Docket Item # 8
BAR CASE # 2008-0130

BAR Meeting
September 3, 2008

ISSUE: Addition and Alterations
APPLICANT: Robert C. and Rebecca L. Fields
LOCATION: 313 South Pitt Street
ZONE: RM/Residential

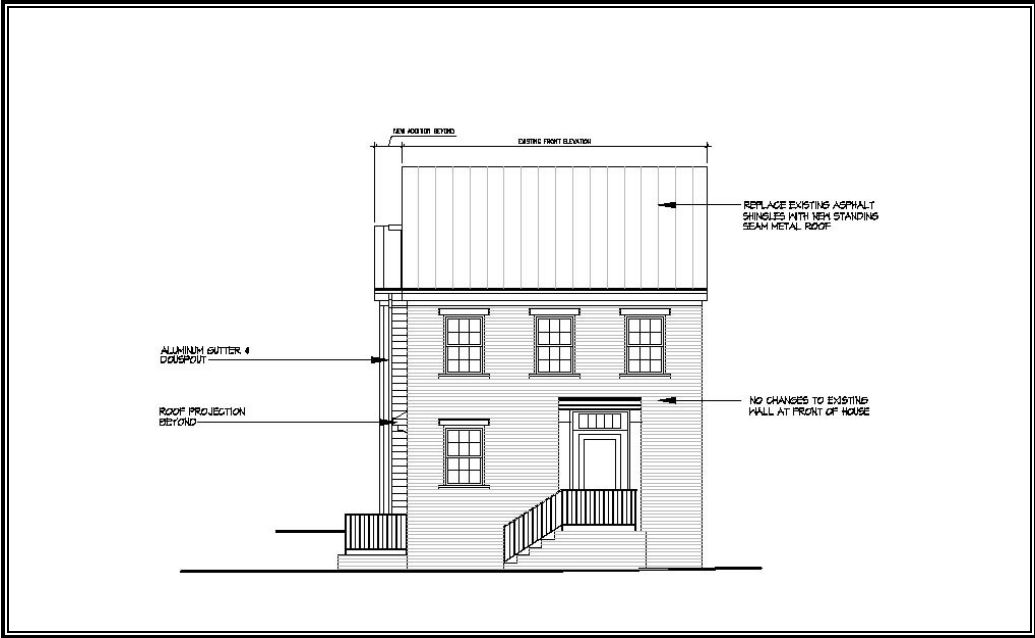
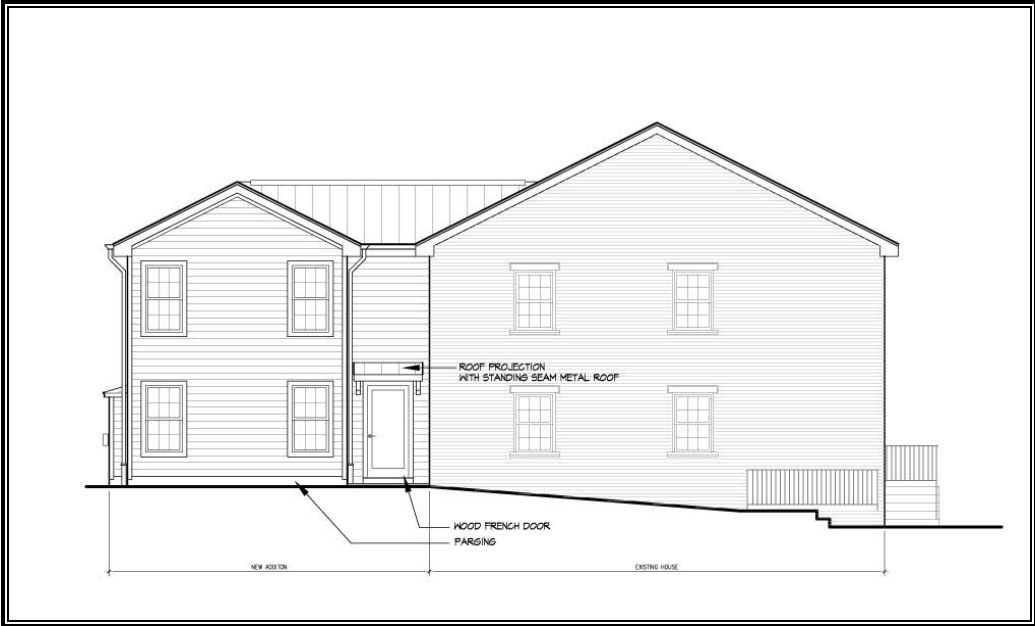
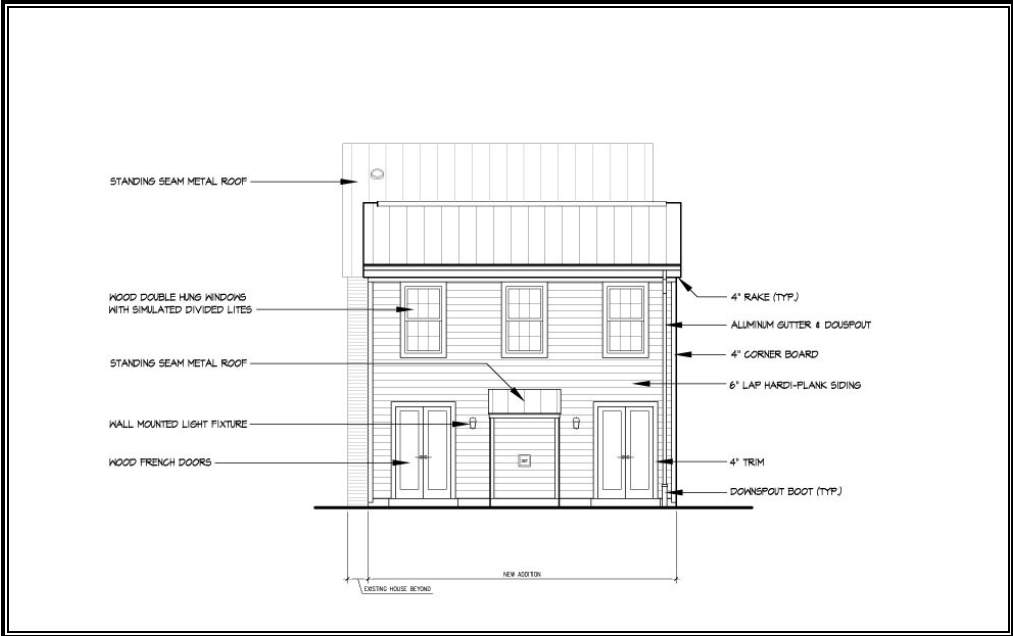
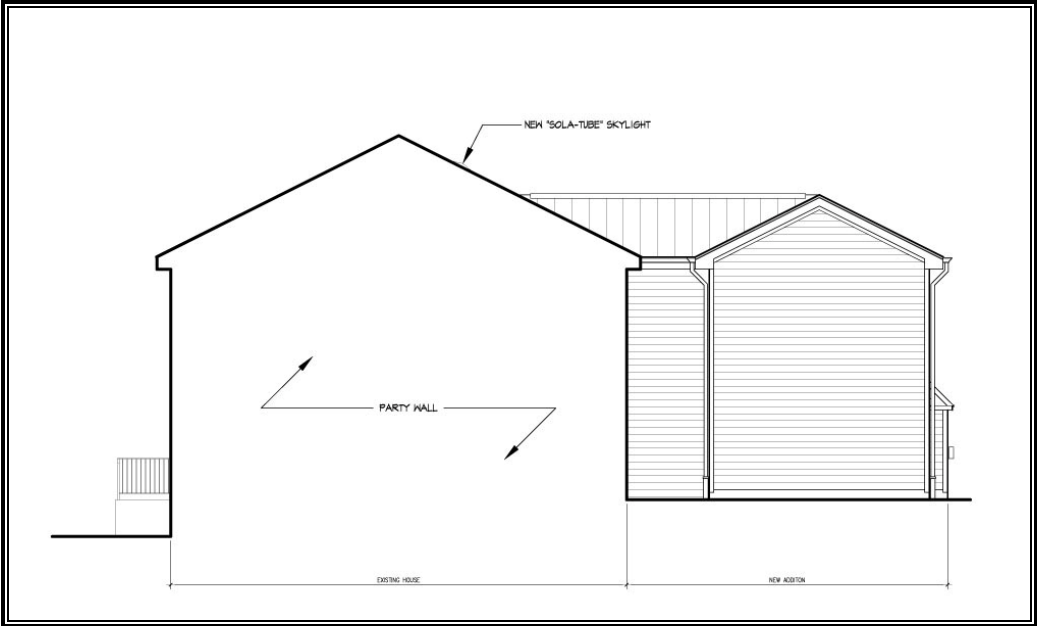
Along the south elevation of the addition - where it meets the existing house - there will be a secondary entrance bay setback from the main plane of the house and the addition with a single, full light French door with a porch overhang. The main block of the addition on the same south elevation will have two six-over-six windows on the first and second floors. On the first floor of the west, rear elevation of the addition there will be a fireplace projection with a standing seam metal roof flanked by double, full light French doors. The second floor of the west elevation is proposed to have the same bay spacing, but with three six-over-six windows. The north elevation of the addition will have no openings due to its location just off the property line.

The addition is proposed to be clad with Hardi-plank siding and the windows and doors will be manufactured by Anderson, 400 Series. The windows are proposed to be double-insulated, simulated divided lights with an interior spacer bar and ¾" muntins. Since submitting the BAR materials the applicant has requested a change from wood to aluminum clad windows and doors. Brass lanterns with a rusticated finish are proposed adjacent to each entrance. The addition will have a standing seam metal roof.

Staff commends the applicant for upgrading the roof from asphalt shingles to standing seam metal. In keeping with the “colonialized” design of the house and the applicant’s proposal to install a metal roof, Staff recommends that the windows on the original house be wood. However, Staff does not object to the replacement of the original true divided light windows with *double-insulated*, simulated divided lights with an interior spacer bar and ¾” fixed muntins. Staff would prefer to see wood windows also installed on the addition, but does not object to the use of aluminum clad windows on the addition due to its limited visibility.

1. That replacement windows installed on the original portion of the house (double-insulated, simulated divided light with an interior spacer bar and 3/4" muntins) be wood;
